HOWARD COUNTY HEALTH DEPARTMENT

RE: Proposed detached garage
12008 Mettee Road

LOCATION DRAWING
CREST ACRES

LOT 3
 HOWARD COUNTY, MARYLAND

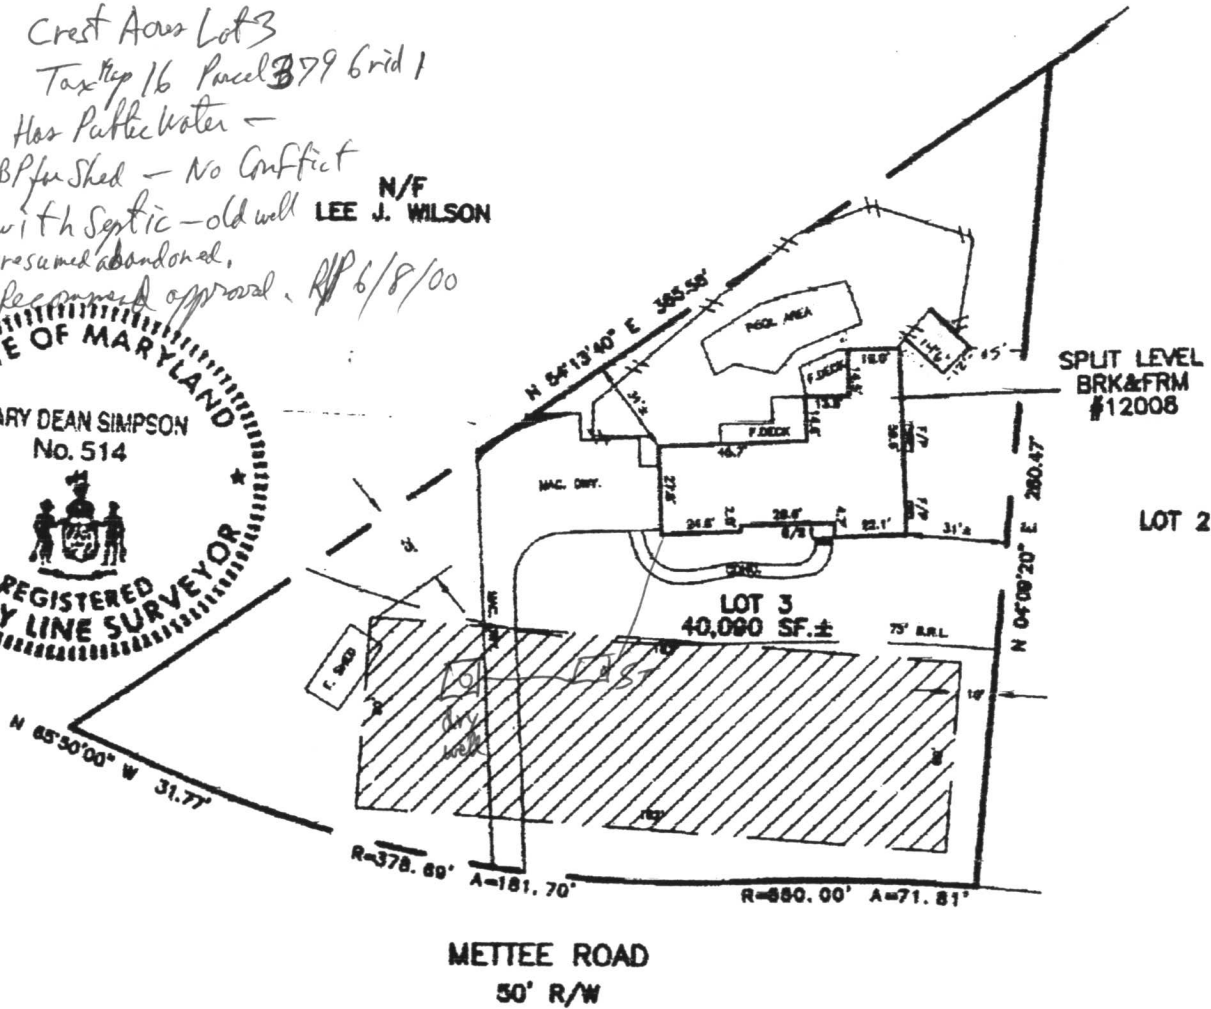
B00124717
 12008 Mettee Rd
 Crest Acres Lot 3
 Tax Map 16 Parcel 379 Grid 1
 Has Public Water -
 BP for Shed - No Conflict
 with Septic - old well
 presumed abandoned,
 Resurvey approval. RP 6/8/00

LOCATION DRAWING
CREST ACRES

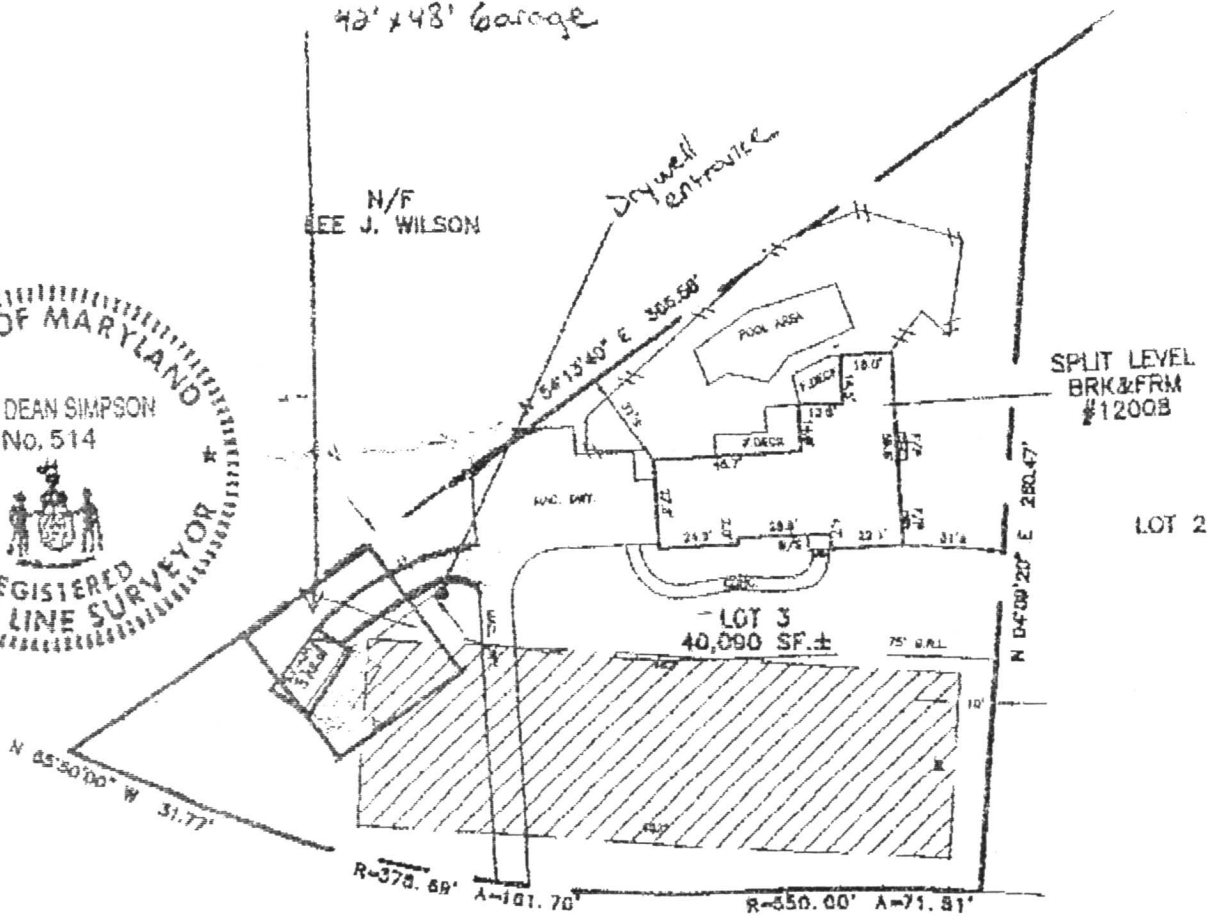
The Health Department has reviewed the proposal to build a detached garage on the above referenced property; however, we are unable to approve the proposal at this time.

As previously discussed with you, all structures shall be at least 20 feet from the septic reserve area, which includes the existing septic system.

Additionally, as you described, the existing public water line was installed through the middle of the existing septic area, rendering a portion of the septic area unusable. It is necessary to maintain 25 feet separation distance from the water line to any portion of a septic system.

Therefore, due to the location of the existing septic system as well as the impact already inflicted upon the septic reserve area, the proposed location of the detached garage is unacceptable by Health Department standards.

spoke to Tricia- I explained to her that Health Dept. approval of this plan is contingent upon relocation of the water line, which currently runs through the middle of the septic area

(location of public water line was provided by owner) (DKS)
